SUBJECT: Forwards addl info re 860702 application for amend License NPF-16 to establish option of storing spent fuel from Unit 1 in Unit 2 spent fuel pool, in response to 870123 request. W/ 12 oversize encl.

Re: St. Lucie Units 1 and 2
Docket Nos. 50-335 and 50-389
Spent Fuel Transfer

REQUEST FOR ADDITIONAL INFORMATION
PROPOSED LICENSE AMENDMENT
SPENT FUEL TRANSFER
ST. LUCIE UNIT 2

TRANSPORTER VEHICLES WHEEL ARRANGEMENT DEAD WEIGHT & MAXIMUM RECOMMENDED WHEEL LOADS

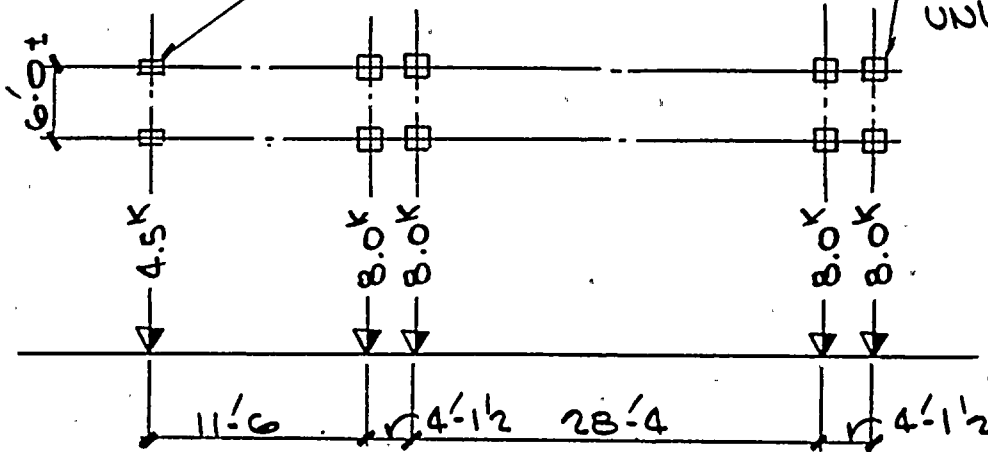
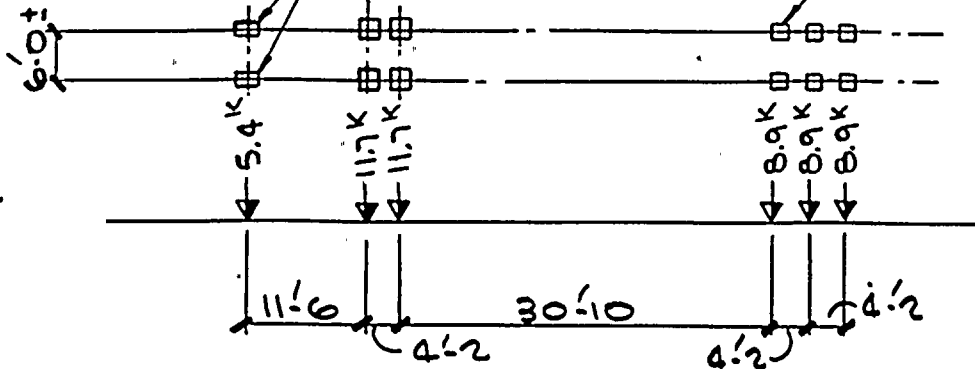
- a. Structure data of the spent fuel shipping cask which will be used to transfer spent fuel assemblies from Unit 1 to Unit 2 spent fuel pool (configuration and basic dimensions, total weight, shipping position..etc.).
- b. Wheel arrangements, maximum recommended wheel loads and dead weight of the two transporter vehicles.
- c. Structural details and plan layouts of missile protection slab and underground facilities to be crossed by the transporter vehicles along the shipping load path.
- d. Results of stress analysis calculations indicating that every structural component listed in item c above shall withstand prescribed sustained and live loads with acceptable margin of safety.

- a. As discussed in the responses to questions 2 and 4 in FPL letter L-87-48, dated February 9, 1987, the spent fuel shipping cask that would be used, if required, would be either the Model NAC-1 or NLI-1/2. These shipping casks have Certificates of Compliance No. 9183, Rev. 3, dated November 14, 1984, and No. 9010, Rev. 17 dated August 28, 1986, respectively, issued by the NRC. Further design details of these spent fuel shipping casks are included in Appendices A and B.
- b. Wheel arrangements, maximum recommended wheel loads and dead weights of the two transporter vehicles are shown on Figure 1.
